SUNSHINE COAST REGIONAL DISTRICT

Question and Answers #3
Request for Proposal No. 2437022
Well Improvements at Chaster Well

Date: October 8, 2024

CHASTER ROAD WELL PUMPING STATION

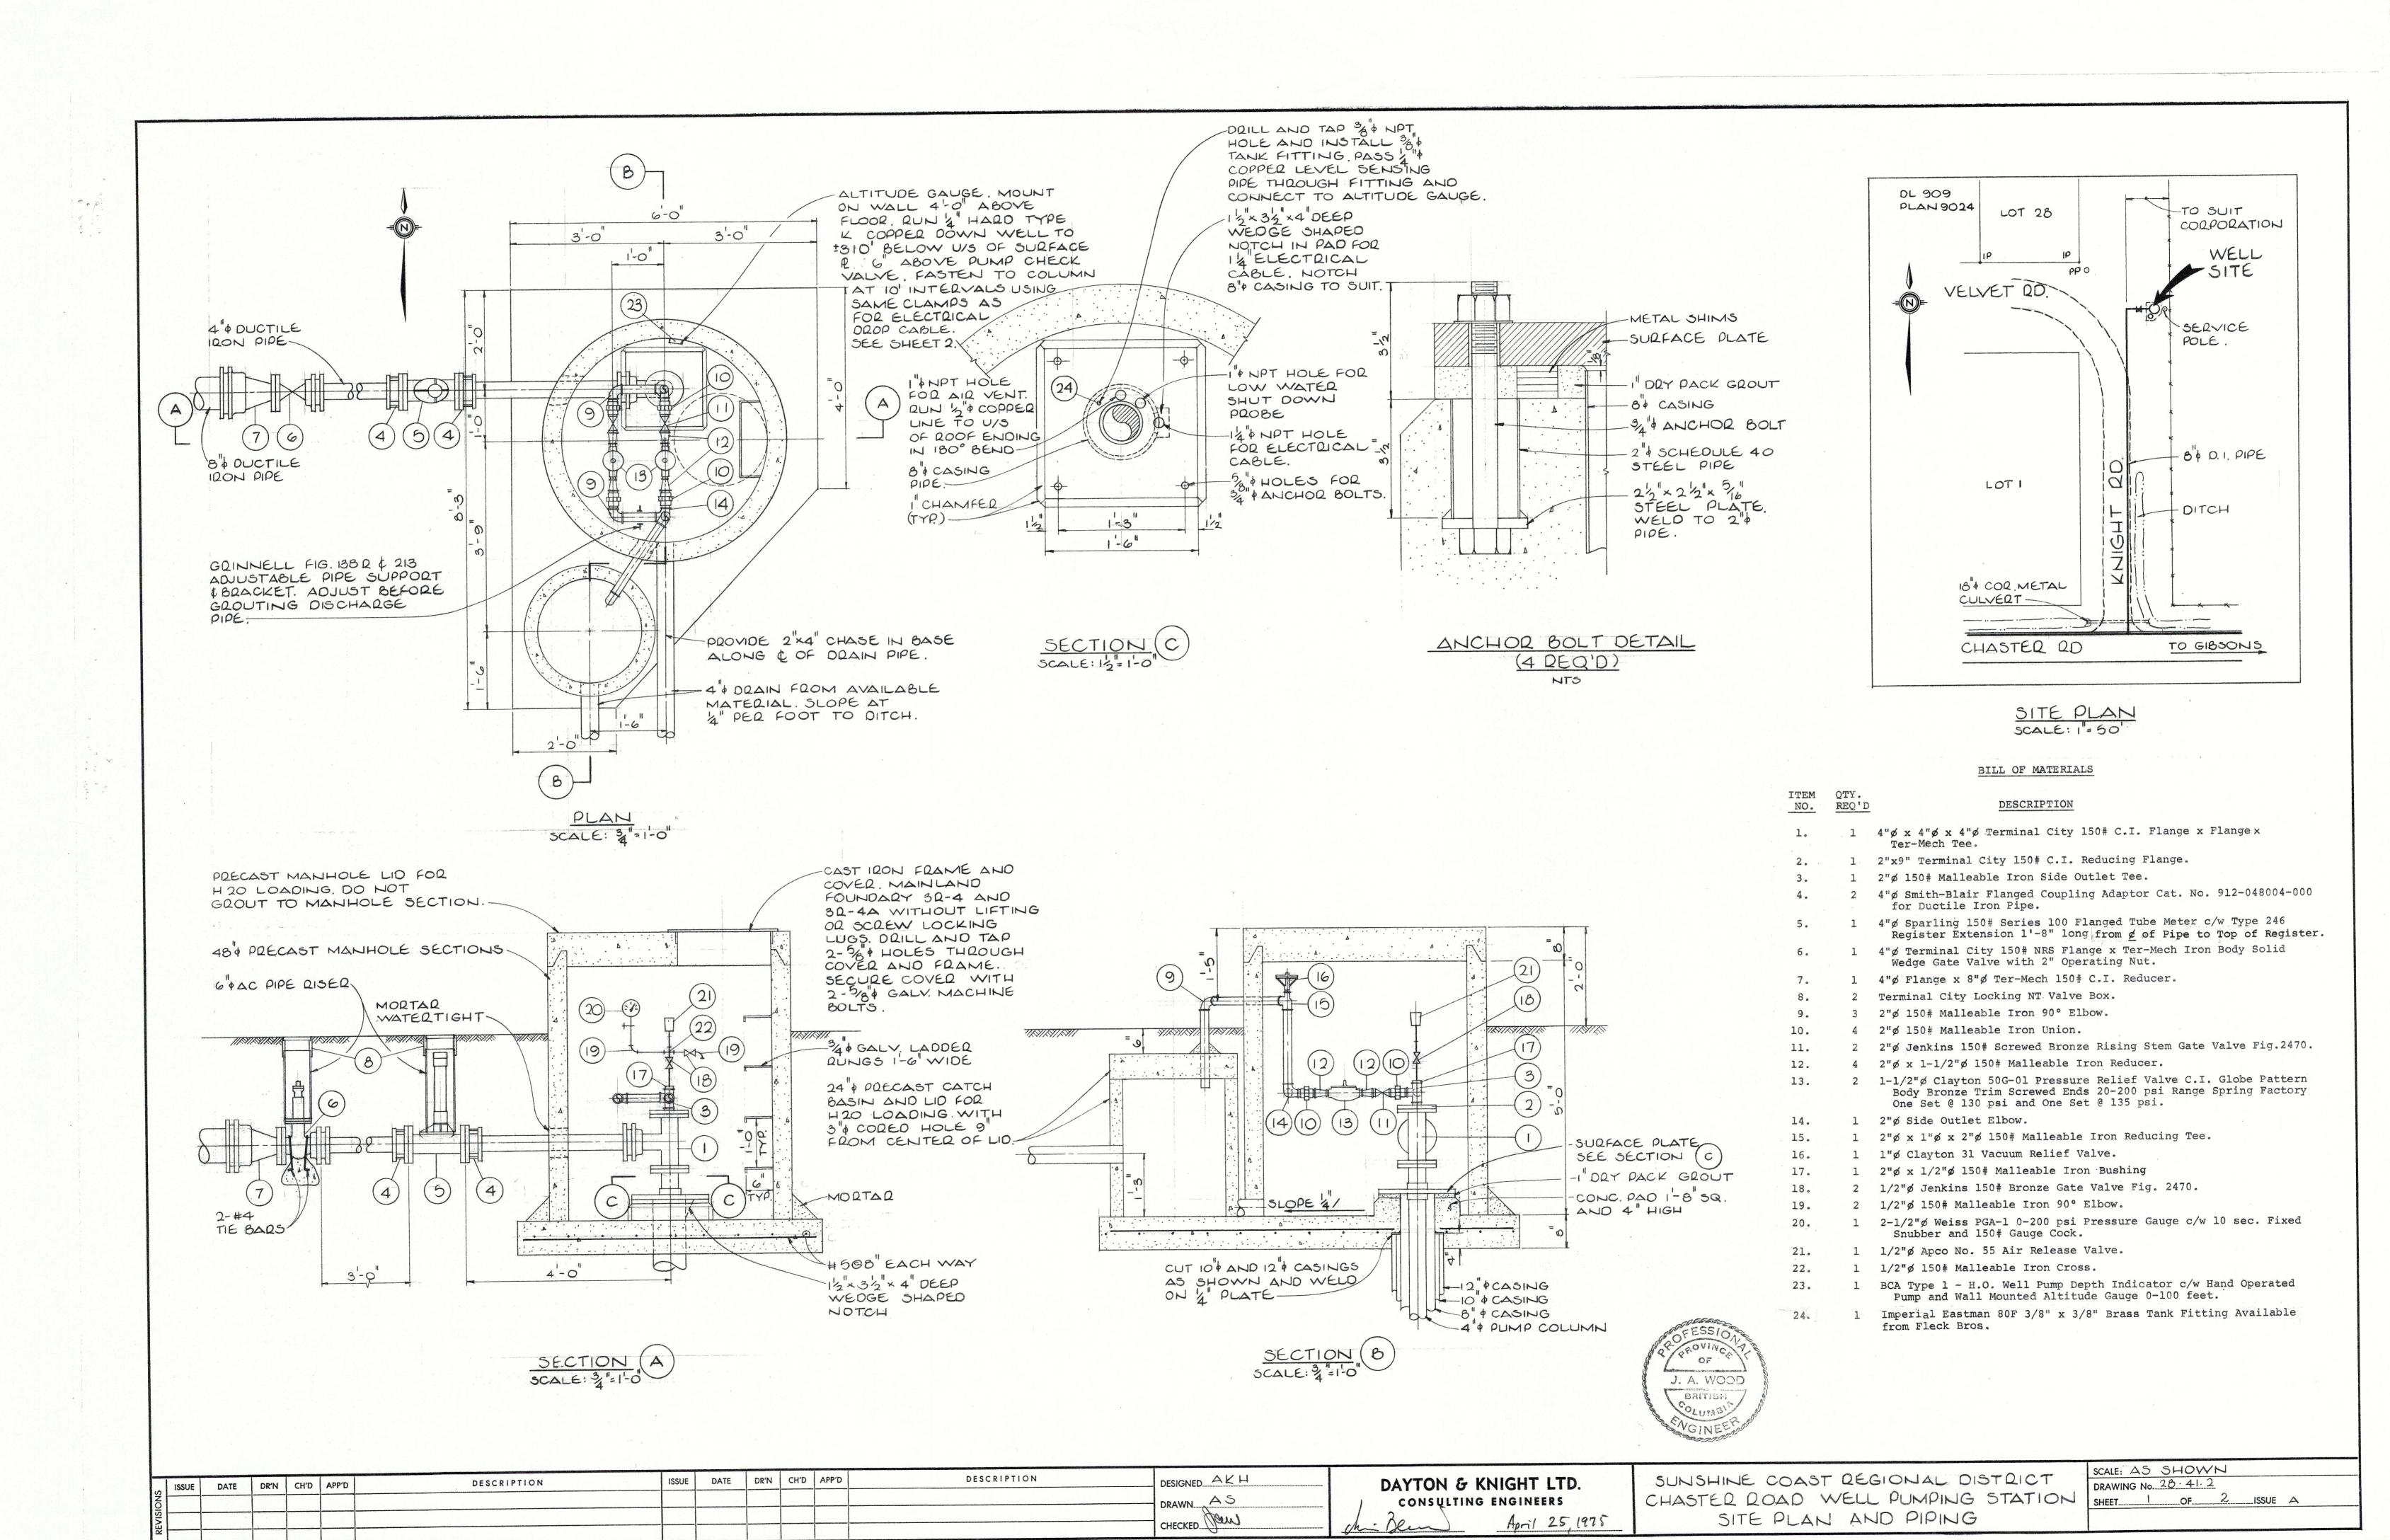
Question: Can you please confirm the following:

- Your well diameter is 12"
- You require 2 Probe tubes in the pitless unit.
- You require 8 "(200mm) flanged discharge and 4" (100mm) drop pipe.
- You require stickup of 200mm (8") The normal stick up is 300mm (12")

- The Well diameter is 12-inch casing with an inner 10 inch and an 8 inch partial casing. See attached Section B of the 1975 drawing.
- 2 Probe tubes are required in the pitless unit.
- An 8 "(200mm) flanged discharge and 4" (100mm) drop pipe is required.
- Contactor to verify stickup height during construction prior to fabricating Pitless adapter and Constructor must submit a shop drawing to the Regional District for review.
